ITEM NO.	PART NO.	DESCRIPTION OR SIZE	QTY. REQ.
PARTS LIST			
UNLESS OTHERWISE SPECIFIED	ORIGINATOR	R. SCHMITT	08-04-99
.XX	ANGLES	B. CYKO	08-04-99
±.02	±.005	C. NILA	08-09-99
1. BREAK ALL SHARP EDGES		R. SCHMITT	08-09-99
2. DO NOT SCALE DIMS.		USED ON	
3. DIMENSIONS IN ACCORD WITH PAR. 114, SMP-1982			
4. ALL DIMENSIONS ARE IN INCHES.			
125	MAX. ALL MACHINED SURFACES	MATERIAL	COPPER OFE 10100
		SURFACE TREATMENT	BRIGHT DIP
 FERMI NATIONAL ACCELERATOR LABORATORY UNITED STATES DEPARTMENT OF ENERGY			
PPD/MECHANICAL SUPPORT CDMS			
GAMMA SHIELD, INNER, HALF "B", 8"			
SCALE	DRAWING NUMBER	SHEET NO.	REV.
FULL	9213.300-MC-384061	1 OF 1	A

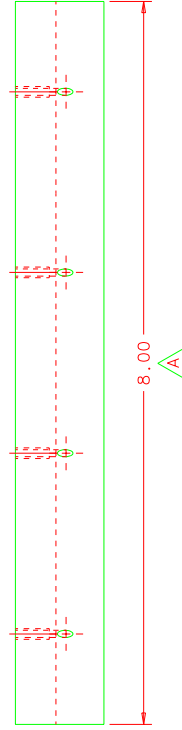
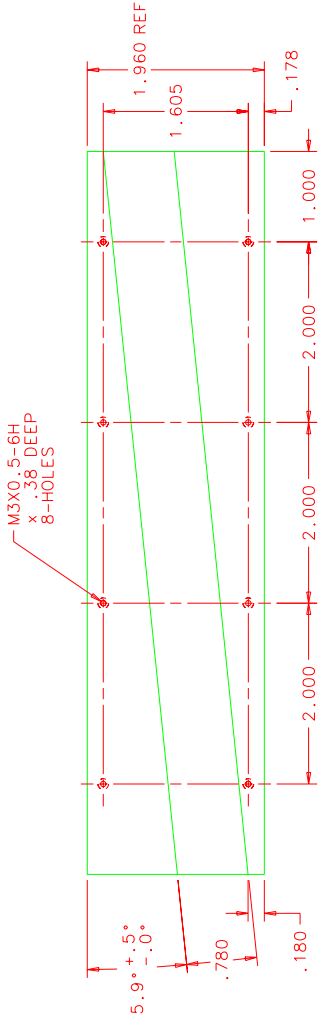
REV.	DESCRIPTION	DRAWN	DATE
A	REVISED LENGTH FROM 4.00 TO 8.00	B. CYKO	09-02-99
